City of Mississauga Department Comments

Date Finalized: 2022-03-30 File(s): A129.22

Property Address: 5217 Mississauga Rd

The applicant is proposing a widened driveway requiring variances for driveway width, driveway coverage area, and side yard setback.

Appendix 1 – Transportation and Works Comments

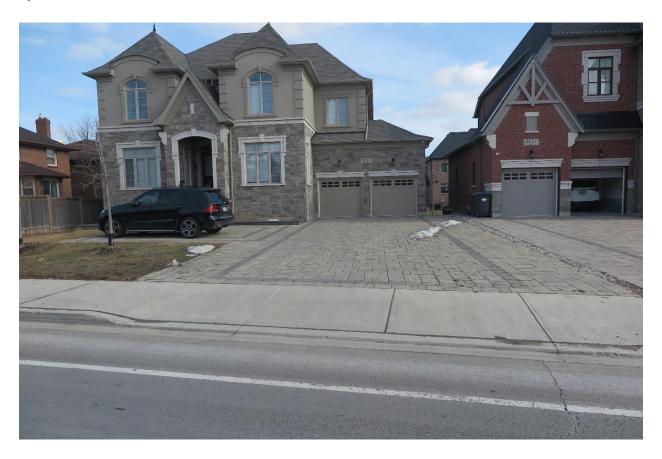
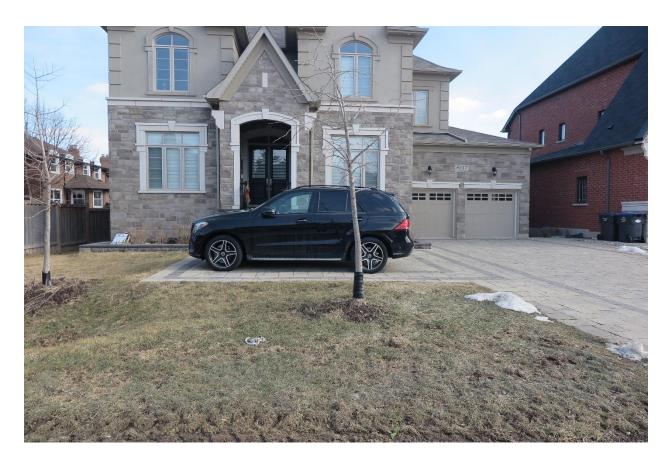
This department notes that with regard to the widened driveway within the municipal boulevard (the area between the municipal curb and property line) we would request that this area be reinstated with topsoil and sod should the application be modified to reflect a smaller driveway width within the subject property or if the application is not supported by the Committee.
